**CONCEPTUAL MASTER
POTABLE WATER SYSTEM REPORT
FOR
SERENO CANYON**

**City of Scottsdale
Water Resources Department**

Basis of Design Review Comments

Project: Sereno Canyon

PLATE 4

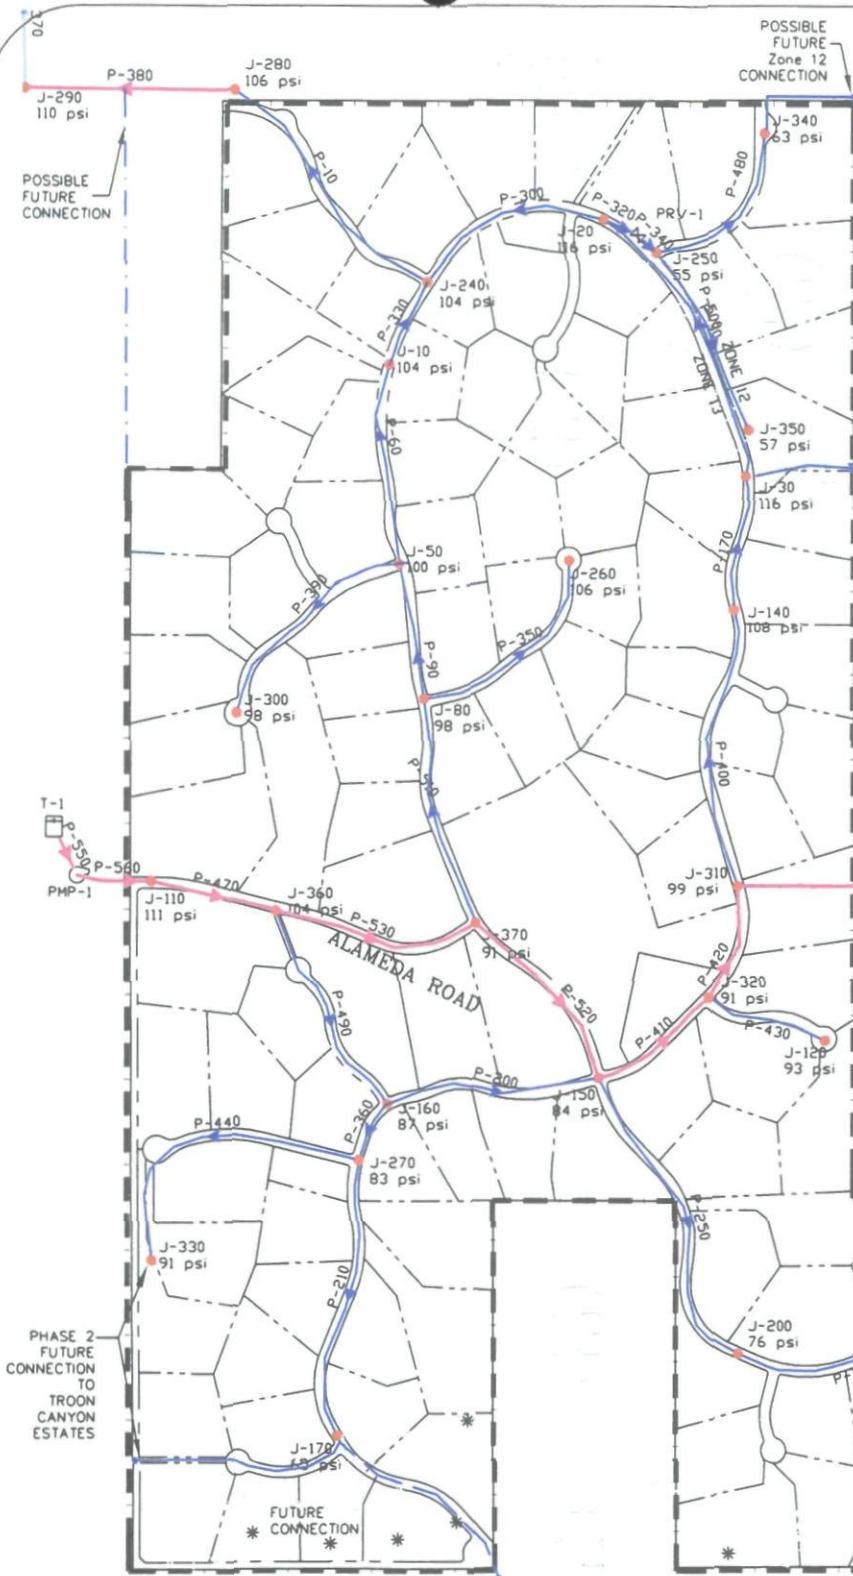
5. Plate 4, Option 1 is to include a line from the cul-de-sac off pipe 390 to the northwest property line for a future connection to the adjacent property. A stub to the property line shall be included off node J-310. A water line will be installed along the 128th Street frontage to this project.
